Date: January 9, 2024

Project No. 141.20174.00002

**RE: Wetland Violation Inspection Summary/Recommendations
Litchfield Hills KOA Campground
232 Klug Hill Road
Torrington, Connecticut**

FIGURE 1

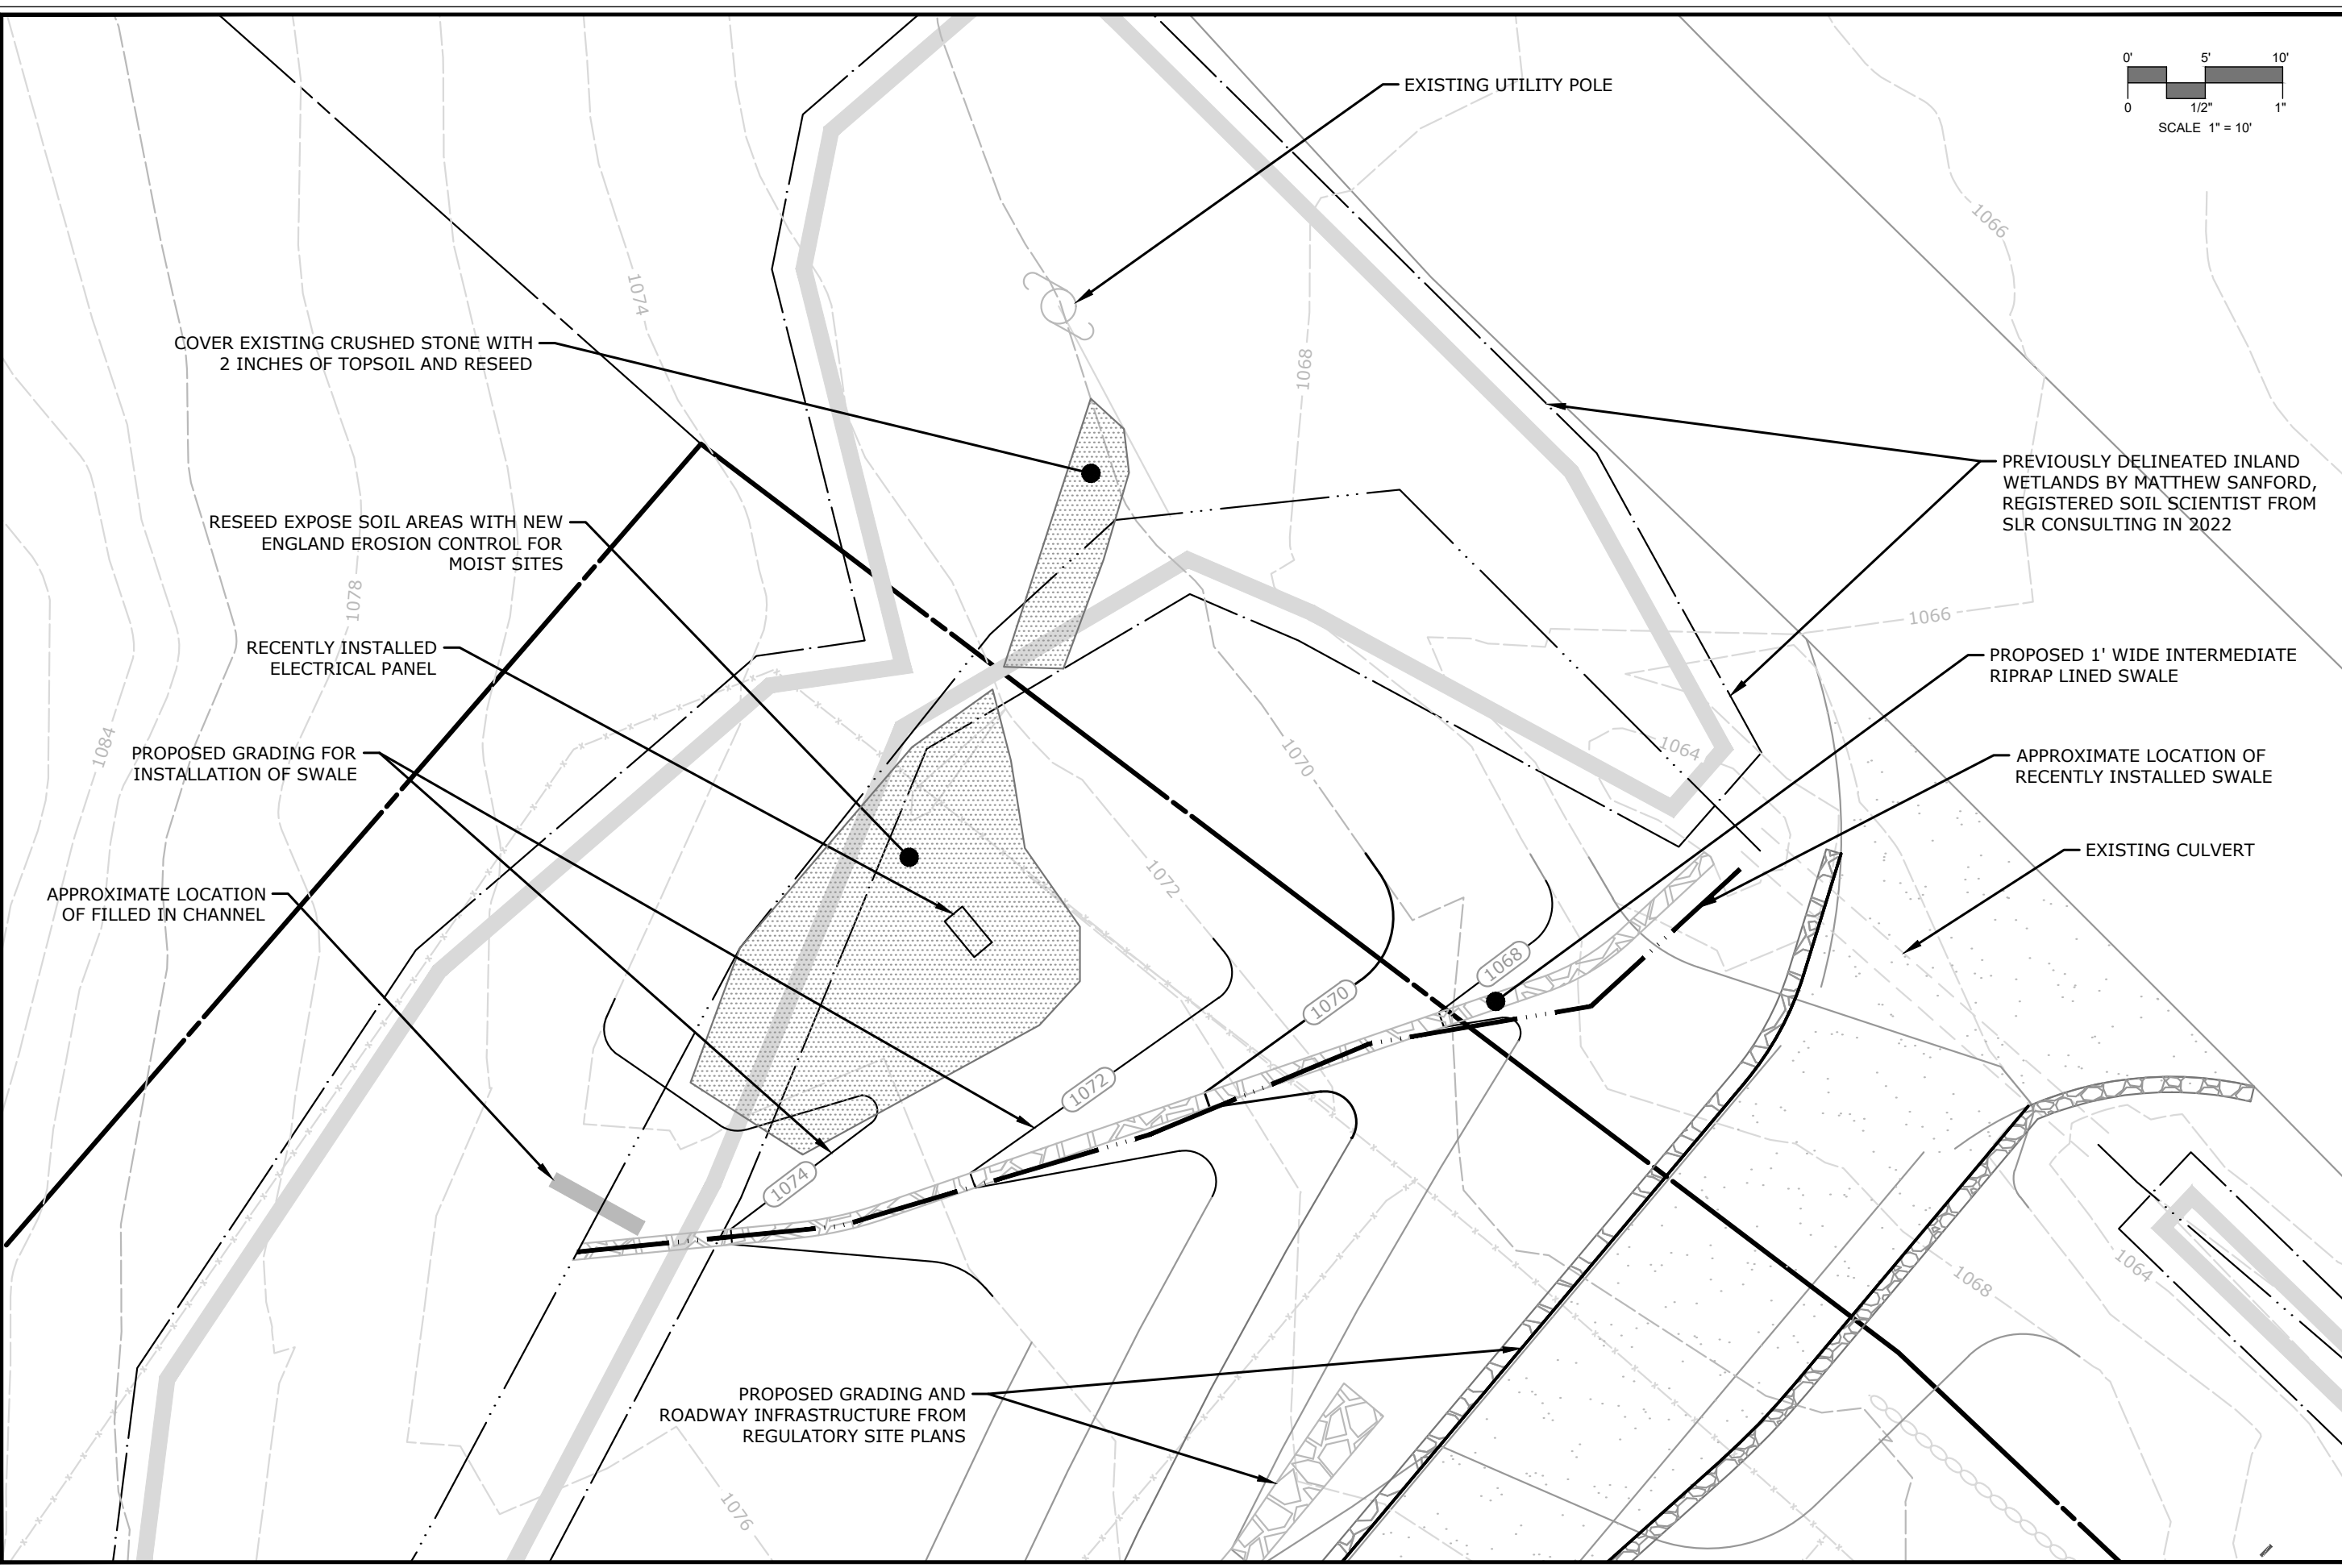
Wetland Violation Area No. 1 is located at the main entrance drive off Klug Hill Road. North of the existing driveway, SLR had previously delineated a farm field wetland and drainage swale that conveyed seasonally high groundwater seepages and stormwater surface runoff east into the right-of-way of Klug Hill Road. There is an Eversource utility pole located within the farm field wetland and is located within the city right-of-way. The landowner retained an electrician and general contractor to install a new electrical panel near the entrance driveway, and the panel was connected via underground utilities to the utility pole described above. During the installation of the panel and associated utility trenching, the existing wetland and swale were disturbed by the activities. In addition, the general contractor placed fill within the existing wetland and drainage swale to prevent water from flowing towards the utility pole and within its original channel. The fill placed within the swale included soil and woody debris and crushed stone (at the trench location). To convey surface water around the utility trench area, the contractor excavated a new drainage swale through the adjacent upland field and redirected surface water flows towards an existing driveway cross culvert. None of these activities had

been permitted. During my visit, I noted that the old drainage swale still had some surface water present, albeit minor as compared to previous site inspections. It should be noted that this swale still receives groundwater seepage from adjacent uplands, which will support/maintain the wetland vegetation growing within the swale.

- Areas that have exposed soil should be seeded with a New England Erosion Control Seed mix for moist sites.
- The crushed stone within the old drainage swale should be covered with a thin layer of topsoil (less than 2 inches) to provide opportunities for revegetation.
- The new drainage swale should be formalized and graded to reduce erosion potential and flooding of the driveway entrance and Klug Hill Road. Round river stones can be used to formalize the channel (see attached Figure 1).

COVER EXISTING CRUSHED STONE WITH 2 INCHES OF TOPSOIL AND RESEED

RESEED EXPOSE SOIL AREAS WITH NEW ENGLAND EROSION CONTROL FOR MOIST SITES

PROPOSED 1' WIDE INTERMEDIATE RIPRAP LINED SWALE

FIGURE 2
 SHEET NO.

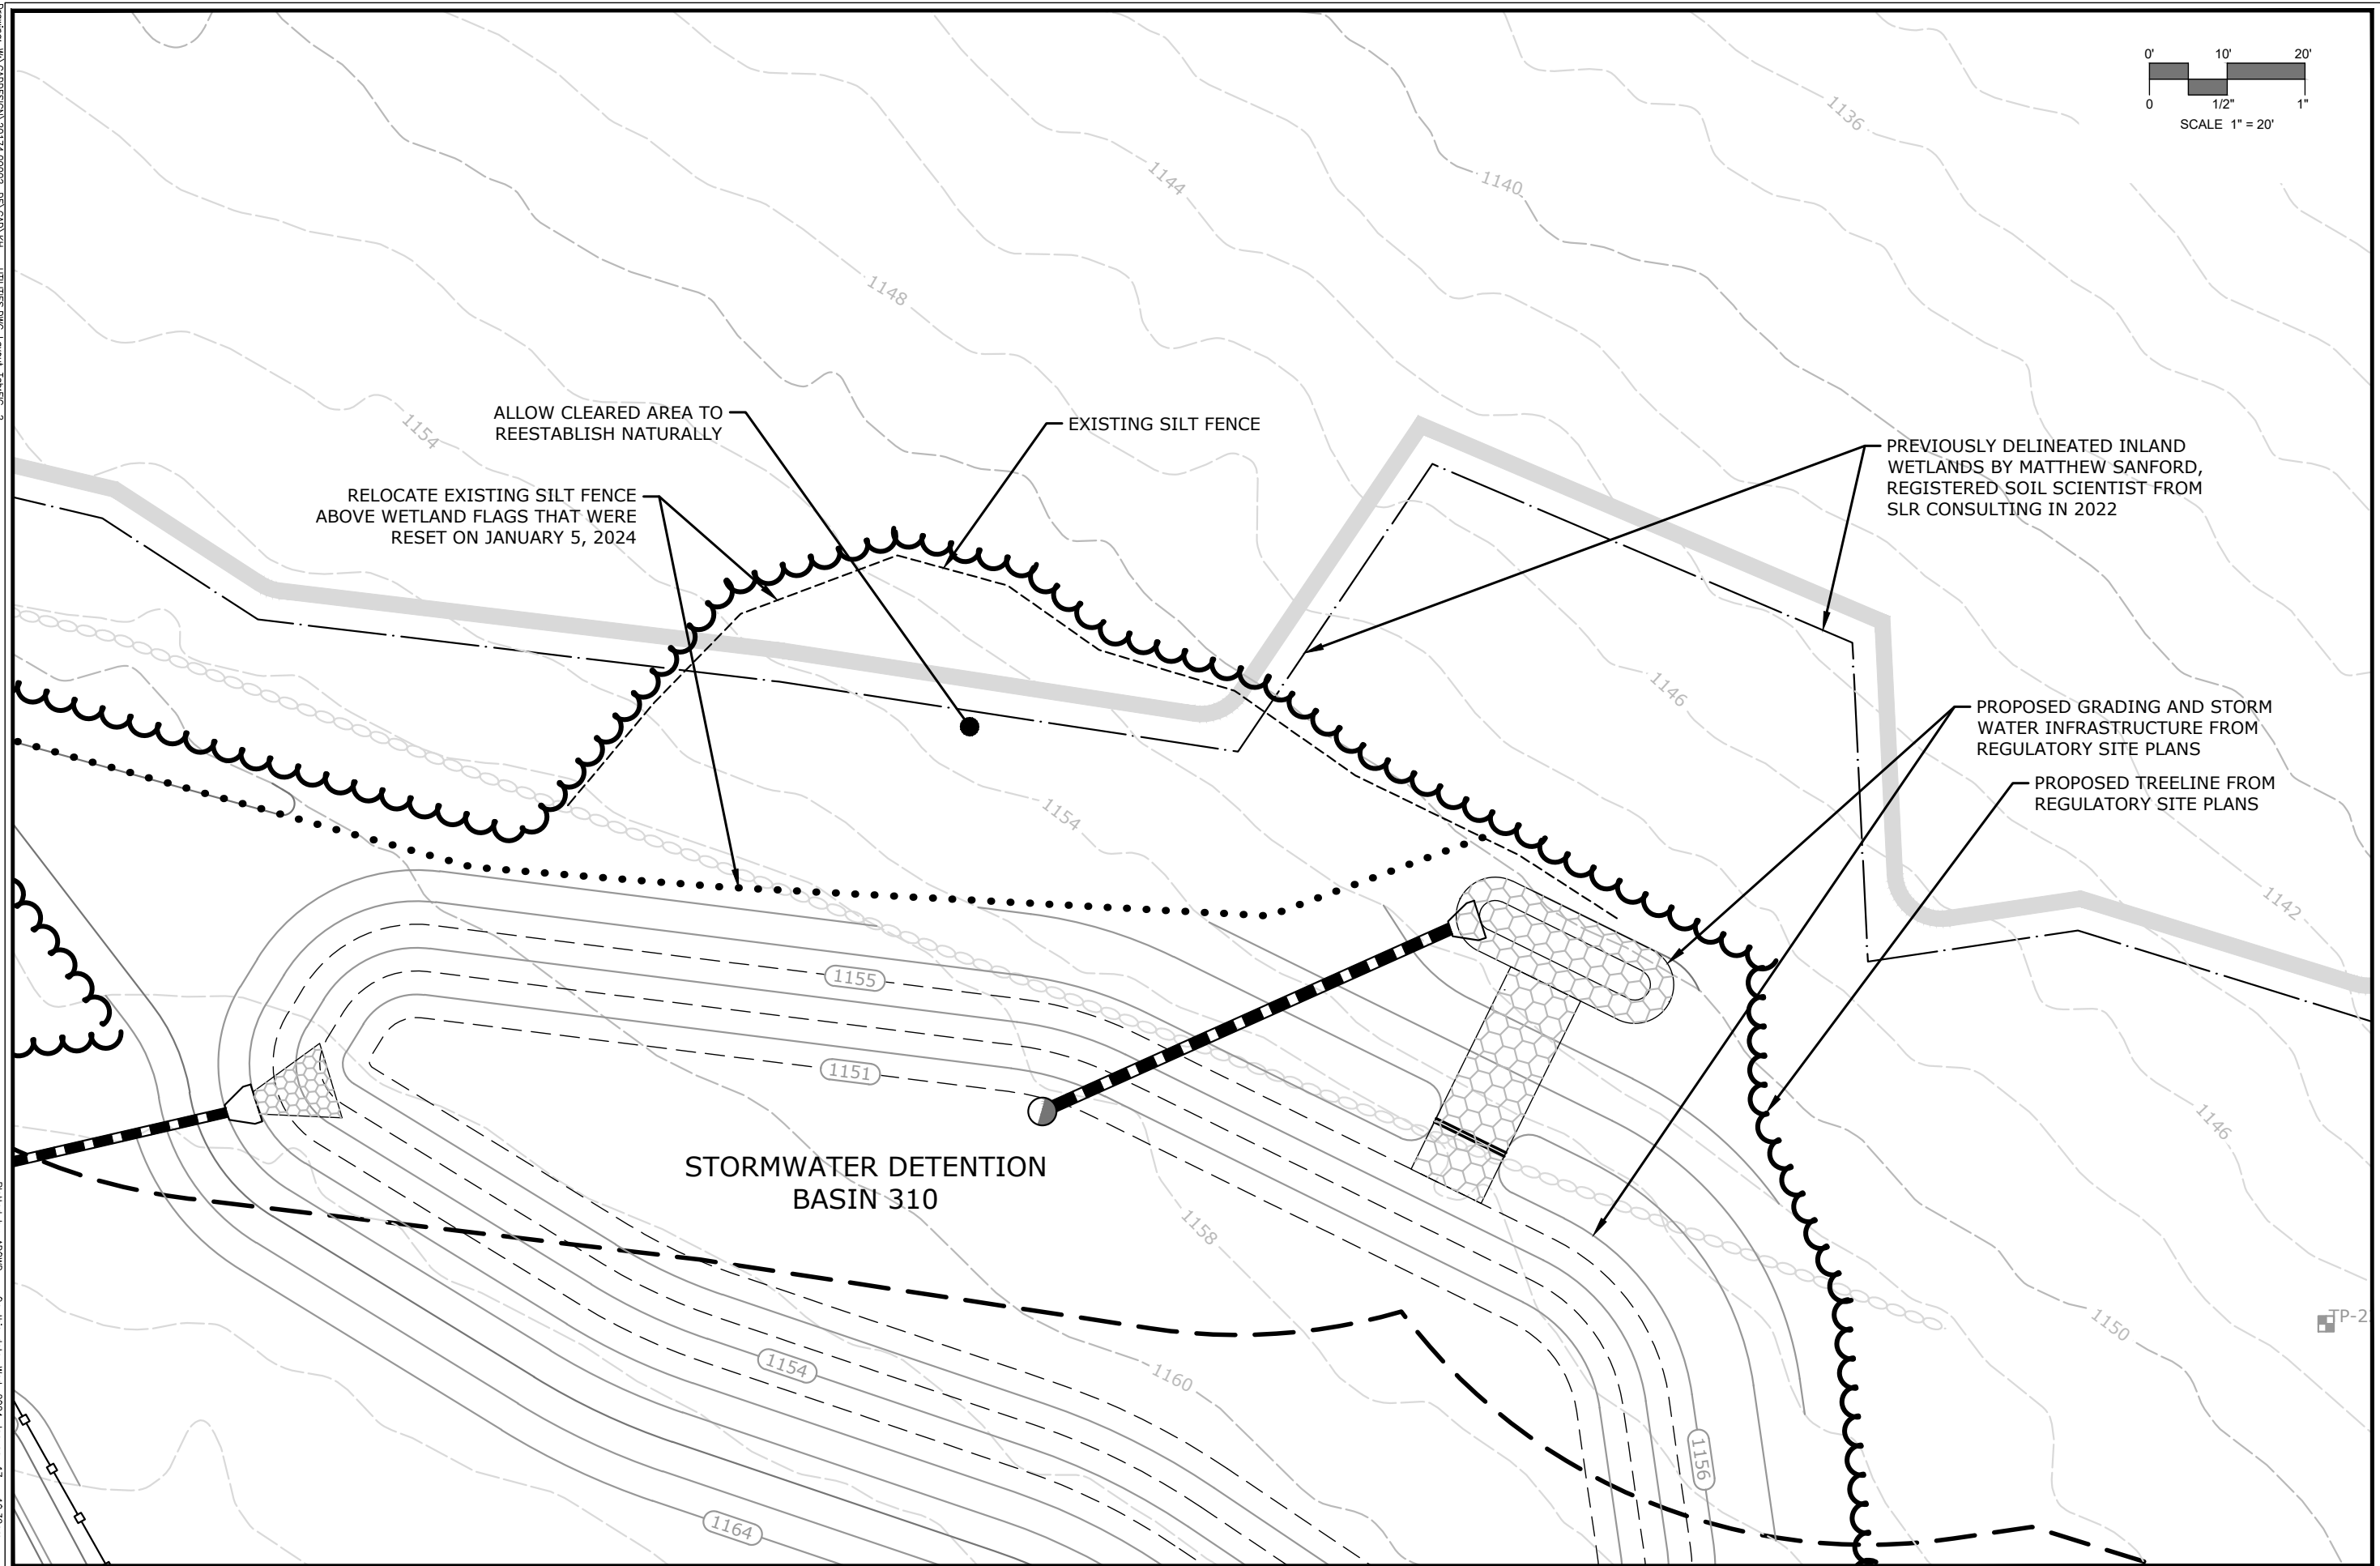
Wetland Violation Area No. 2 is located north of stormwater detention basin No. 310 and includes overclearing, grubbing, and installation of a geotextile silt fence within a regulated wetland. The general contractor cleared a small portion of a forested wetland during clearing and grubbing operations and installed the silt fence through the cleared wetland. The contractor grubbed the area within and adjacent to the wetland and disturbed a portion of the soil solum. This disturbance mixed some of the soil horizons, making the wetland boundary less definitive in the field than preconstruction conditions. SLR set new blue and pink wetland flags at this location based on current field conditions. The wetland area that was cleared is well vegetated with a variety of wetland herbaceous plants, including soft rush, sensitive fern, and sedges.

- Remove and relocate a segment of geotextile silt fence outside/upgradient of the wetland flags placed in January 2024. This includes approximately 60 linear feet of silt fence relocation (see Figure 2).
- Allow wetland to regrow naturally. No supplemental plantings are recommended.
